# PROPOSED SITE DEVELOPMENT

## 46-64 MAPLEWOOD AVENUE

## PERMIT SITE PLANS

PLAN SET ISSUED: 6 FEBRUARY 2018

D2

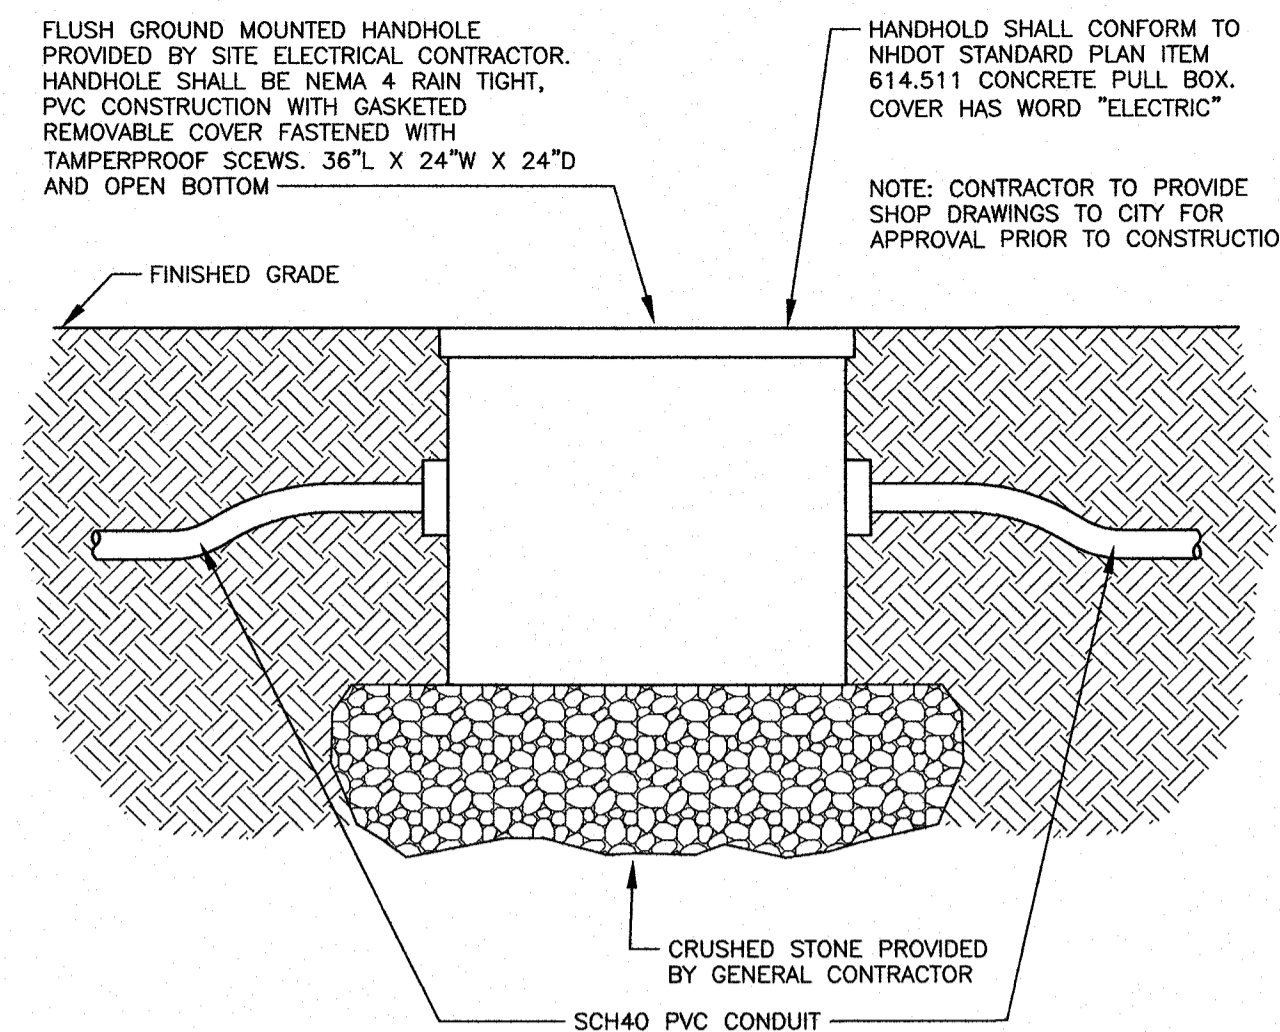
1. Prior to submission for Planning Board, add additional information to the plans as noted by TAC including:
  - a. Update Detail H, Sheet D2 to reflect the Pinehall 4"x8" standard. **This has been drafted on Sheet D2 – Detail H.**

**M C5** TYPICAL SITE LIGHTING HANDHOLE NTS

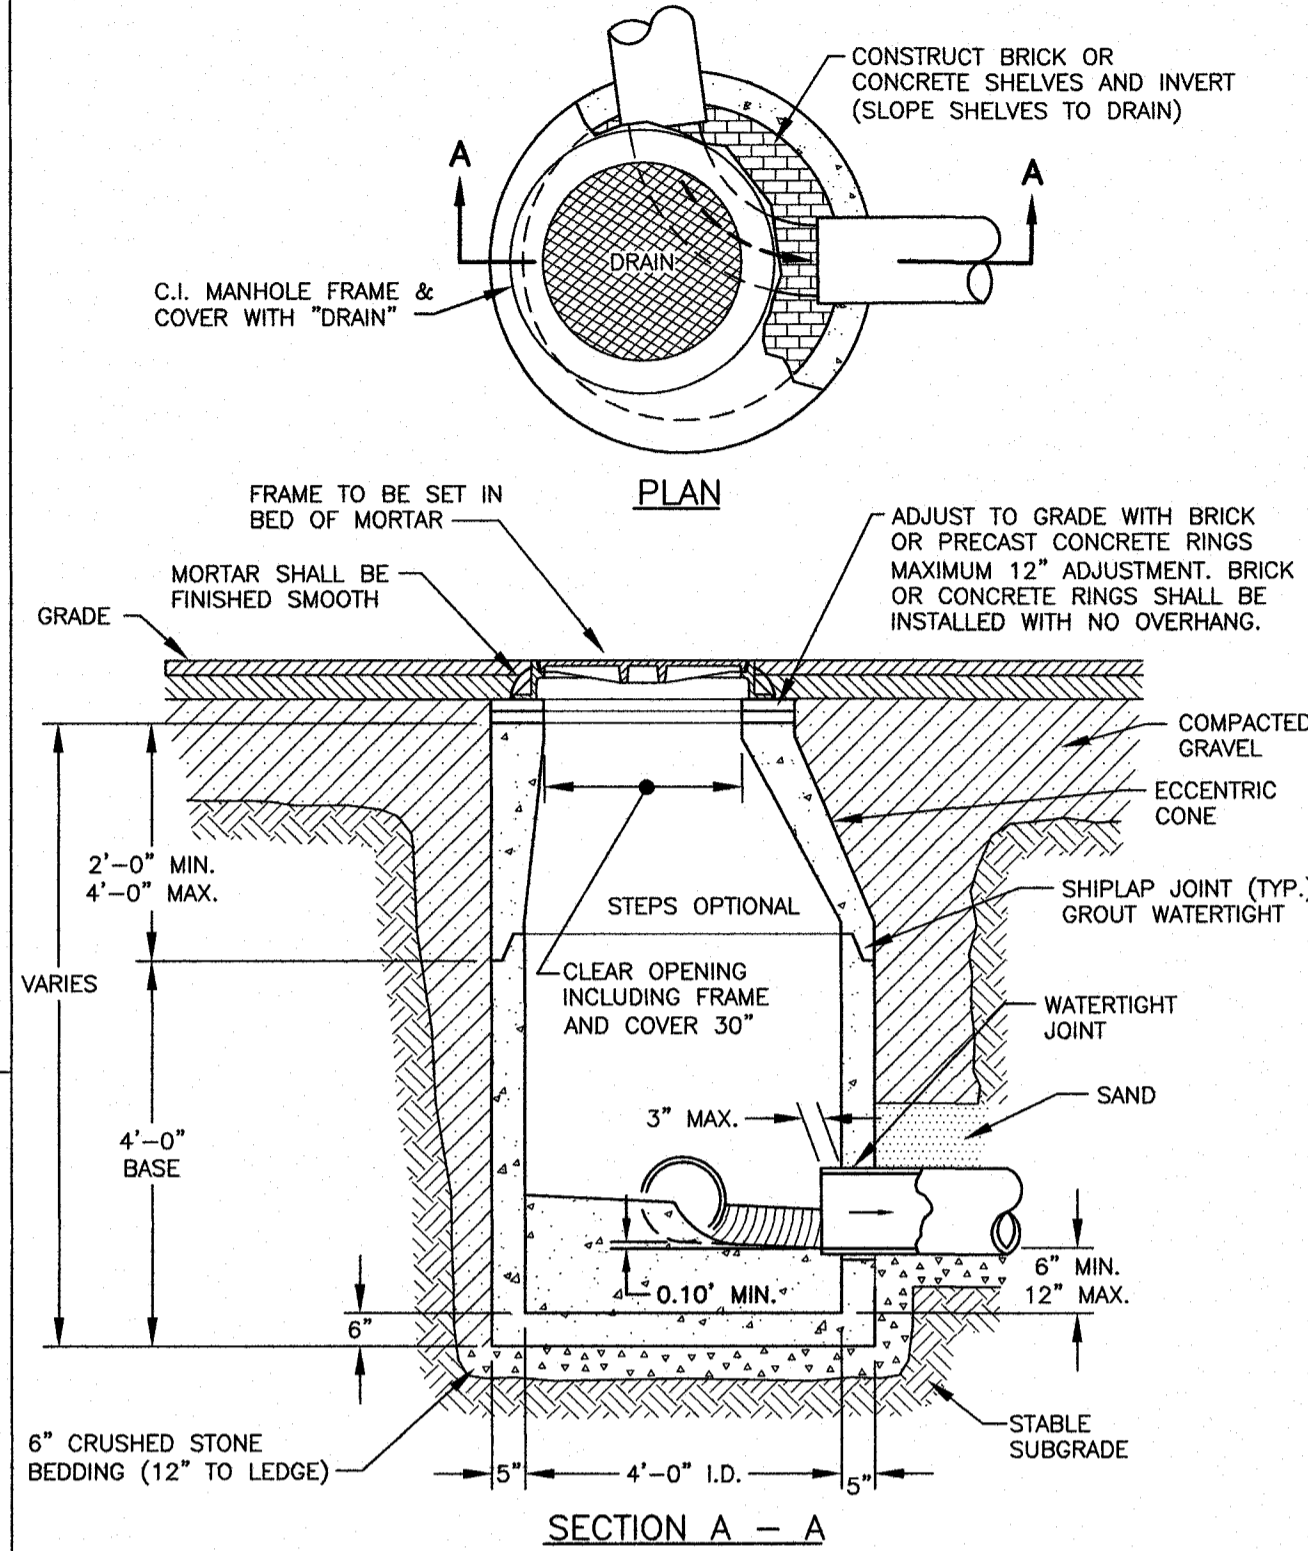
- j. Proposed grade marks shall be removed from the pavement on Deer and Bridge Street. **This has been reflected in Sheet C6.**
  - k. The detail for handholes in the City sidewalk shall be updated as specified. **This has been reflected on Sheet D3 as Detail M.**

**O C5** FIRE HYDRANT INSTALLATION DETAIL PORTSMOUTH NTS

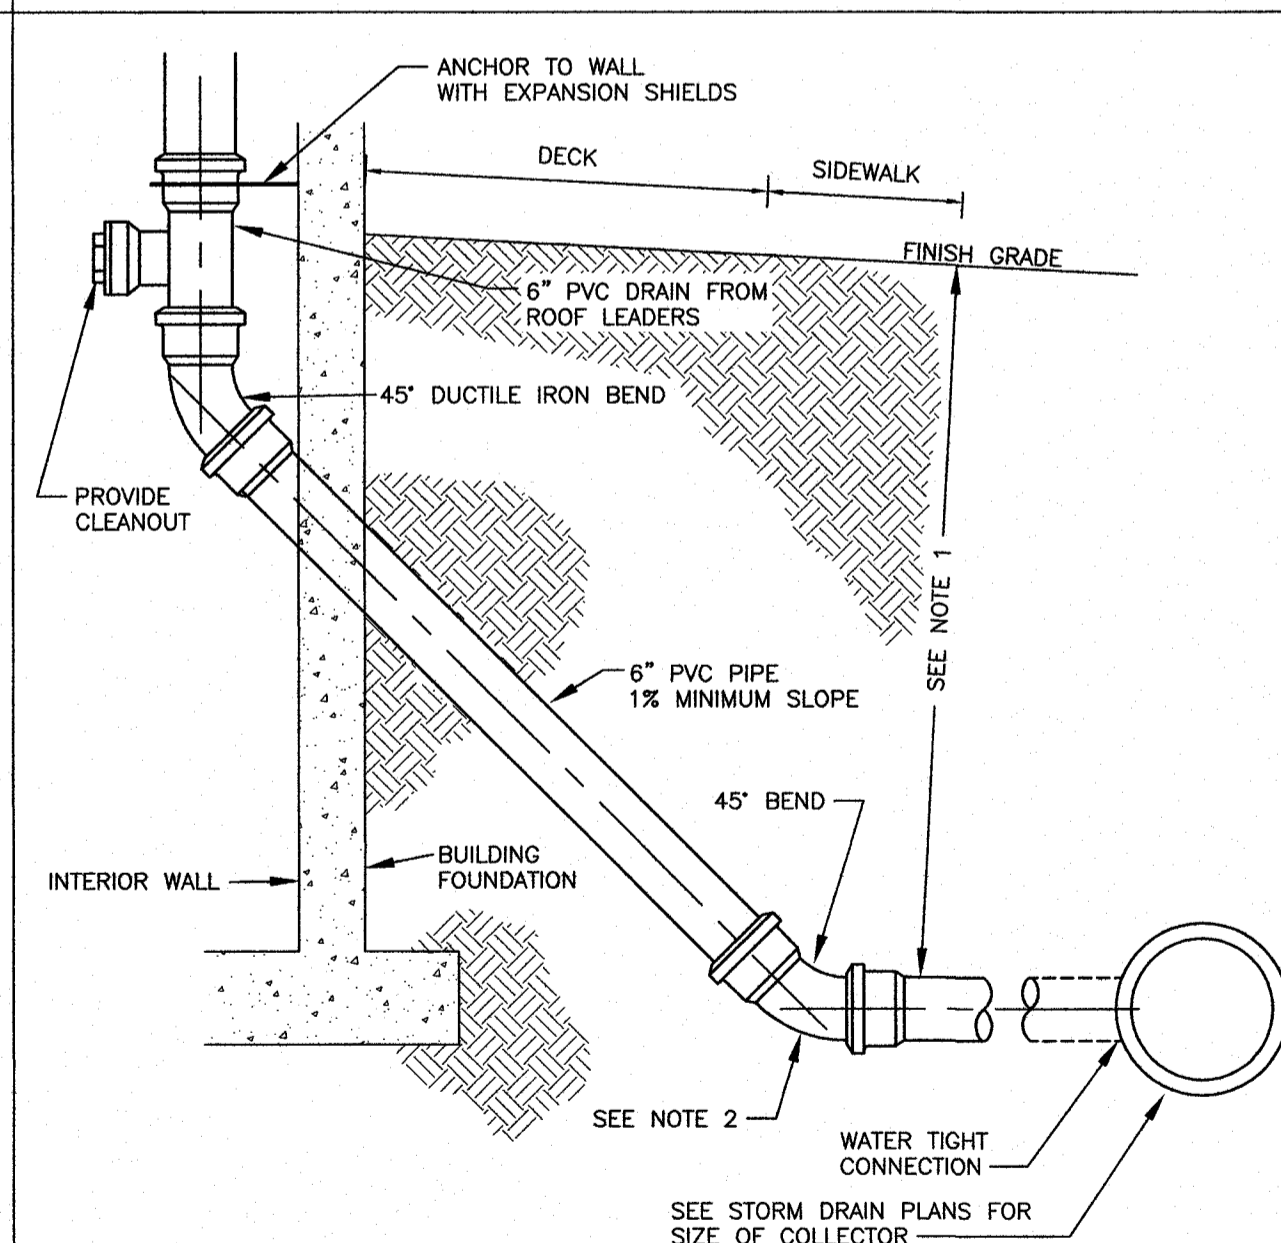
- l. The detail for the thrust block behind hydrant shall be updated as specified. **This has been reflected on Sheet D3 as Detail O.**
  - m. The drawing should reflect grease trap structures capable of H2O loading. **This has been reflected on Sheet D4 as Detail V.**
